SERVICE DIRECTIVE BULLETIN NO. T-060

Revision 1
Page 1 of 11

1. SUBJECT: Fiberglass Procedure for Upper Plenum/Air Inlet Hand Holds and Nutplate Rivets
2. MODEL: 480 and 480B
3. EFFECTIVITY: S/N 5226 and prior
4. BACKGROUND:

Figure 7. FR 7704-00 polyester resin applied to fiberglass patch

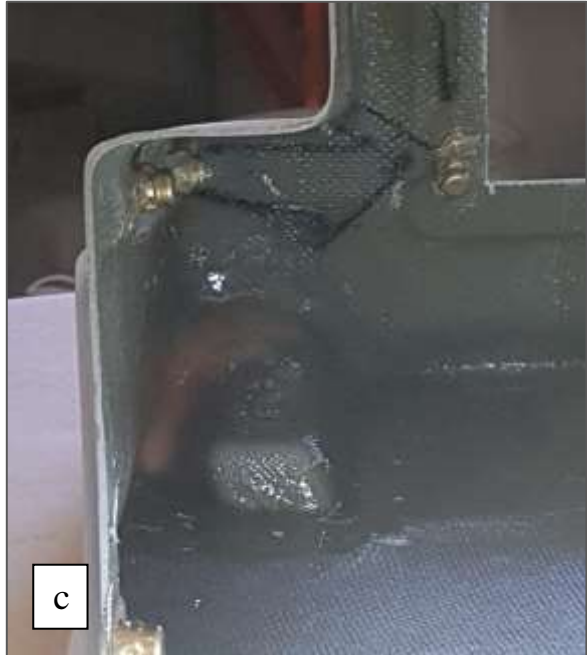
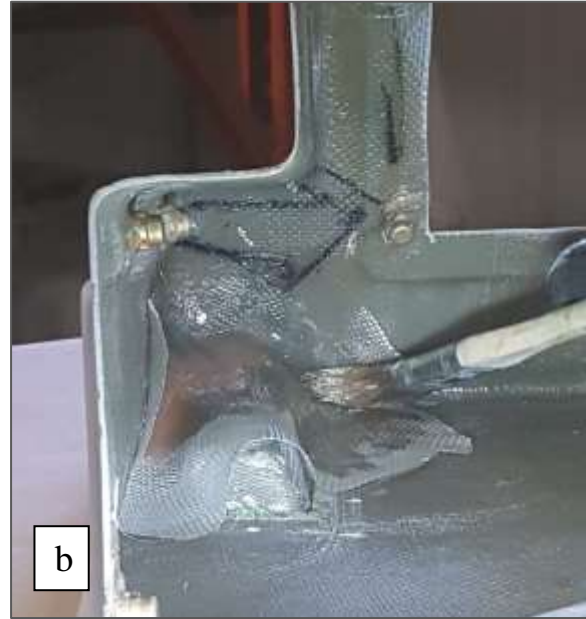
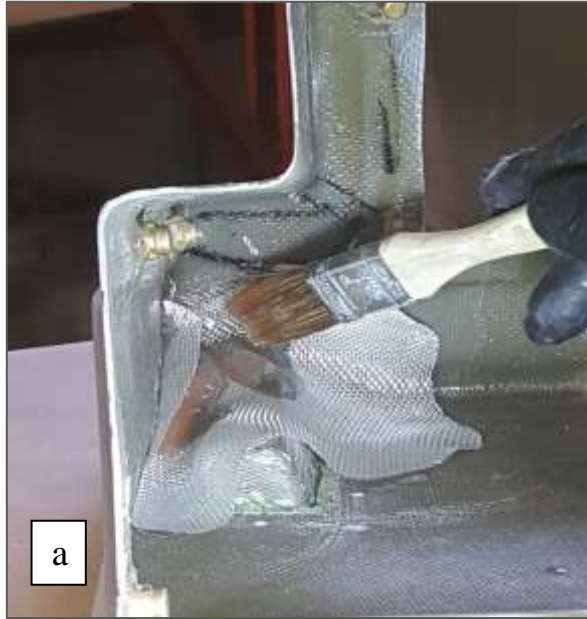
- 6.4.6 With a brush, apply the FR 7704-00 resin to the fiberglass patch until the entire patch is completely saturated (Figures 7a-7d). Ensure the patch is adhered completely to the plenum surface.

Figure 8. Fiberglass patch for nutplates

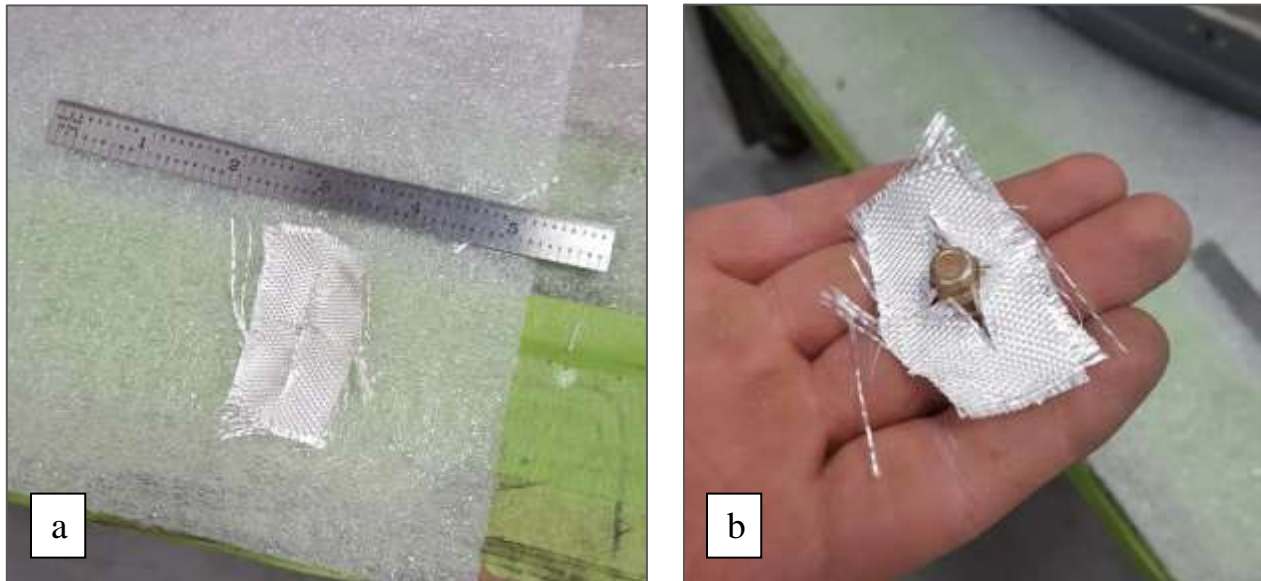
6.5.2 Cut a rectangular piece of 5.8 oz fiberglass cloth (approximately 1 inch/25 mm x 2 inch/51 mm) for each nutplate (Figure 8a). Cut a small "X" in the middle of the patch to enable fit over the nutplate anchor nut as shown in Figure 8b.

Figure 12. Completed fiberglass patch (interior and exterior nutplates)

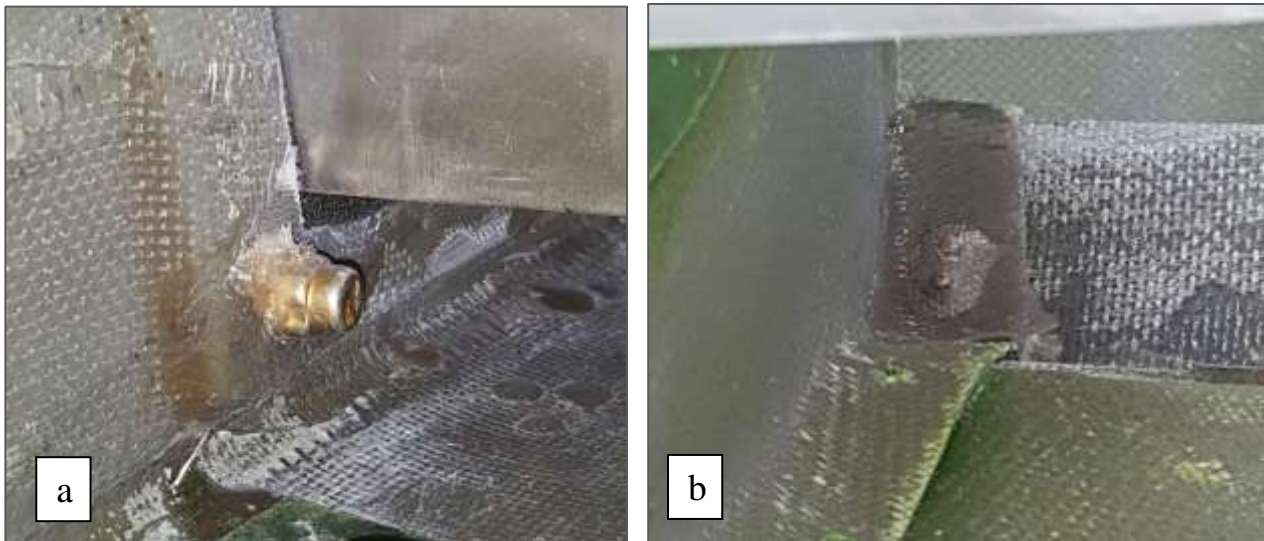
For the exterior nutplate assembly (two places) shown in Figure 9, cutting an "X" in the fiberglass patch is not necessary as this patch only covers the rivets on the inside of the upper plenum/air inlet (Figure 12b).

- 6.6 Once the hand holds and all nutplates have been patched, allow the polyester resin to set for a minimum of 12 hours before handling. Full cure is achieved in 48 hours.
